DART AEROSPACE LTD	Work Order:	97707
Description: Crosstube Assembly (206L High Fwd)	Part Number:	D206-667-143
Inspection Dwg: D206-667-143 Rev: C		Page 1 of 2

DRAWING NO. D206-667-143	TITLE CROSSTUBE ASS'Y (206L HIGH FWD)	REV. C	DART AEROSPACE LTD ENGINEERING ORDER		D.E.O. NO. D206-667-143-C-1	SHEET NO. SHEET 1 OF 1	SCALE NTS
DRAWN <i>qp</i>	CHECKED <i>ASS</i>	MFG. APPR. <i>[Signature]</i>	APPROVED <i>[Signature]</i>		DE APPR. <i>[Signature]</i>		
DATE 11.07.15	DATE 11.07.20	DATE 11.07.21	DATE 11/07/21		DATE 11.07.21

DRAWING NO. D206-667-143	TITLE CROSSTUBE ASS'Y (206L HIGH FWD)	REV. C	DART AEROSPACE LTD ENGINEERING ORDER		D.E.O. NO. D206-667-143-C-2	SHEET NO. SHEET 1 OF 1	SCALE NTS
DRAWN AJS	CHECKED	MFG. APPR. <i>E</i>	APPROVED <i>AP</i>	DE APPR. <i>TH</i>			
DATE 12.08.02	DATE 12.08.02	DATE 12.08.02	DATE 12.08.02	DATE 12.08.02

DETAIL P
BONDING STRAP INSTALLATION 2 PL

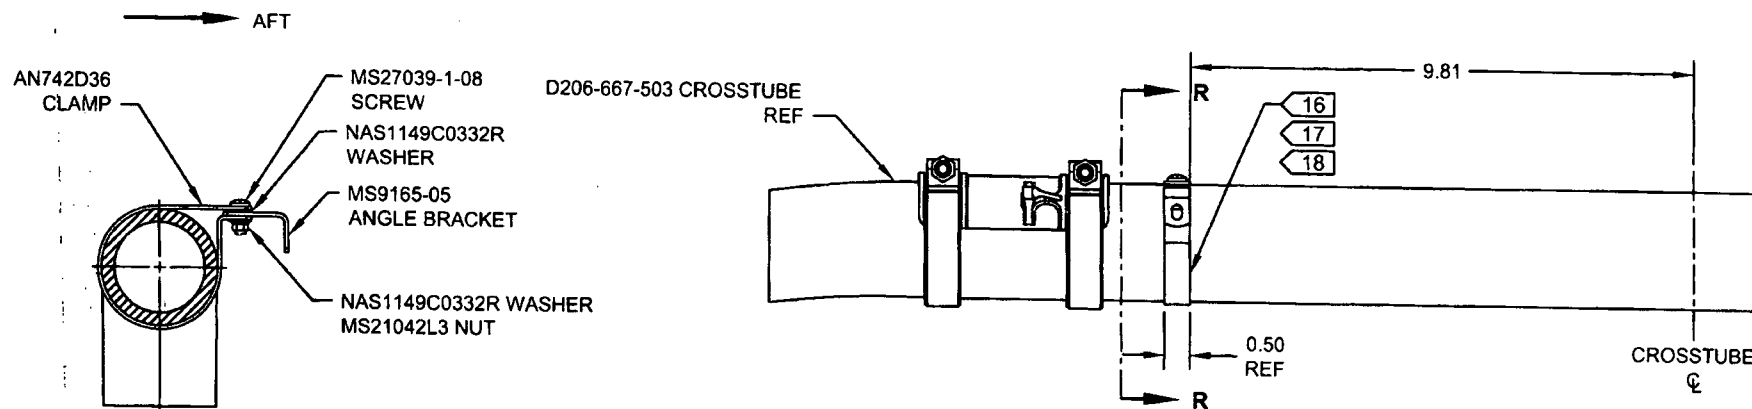
PURPOSE:

ADD ELECTRICAL GROUNDING STRAP

ITEM	QTY -143	PART NUMBER	DESCRIPTION
1	X	D206-667-143	CROSSTUBE ASSEMBLY (206L HIGH FWD)
10	2	AN742D36	CLAMP
11	2	MS9165-05	ANGLE BRACKET
12	2	MS21042L3	NUT (OR MS21042-3)
13	2	MS27039-1-08	SCREW
14	4	NAS1149C0332R	WASHER (OR AN960C10L)

- 16) MASK AREA UNDER CLAMP PRIOR TO PAINTING
- 17) SEAL EDGES WHERE AN742D36 CLAMP MEETS WITH THE CROSSTUBE USING SIKAFLEX-2411-291 OR MIL-S-8802 CLASS B2 OR PROSEAL 890 SEALANT
- 18) PERFORM RESISTANCE CHECK TO ENSURE MAX RESISTANCE IS 10 MILLIOHMS
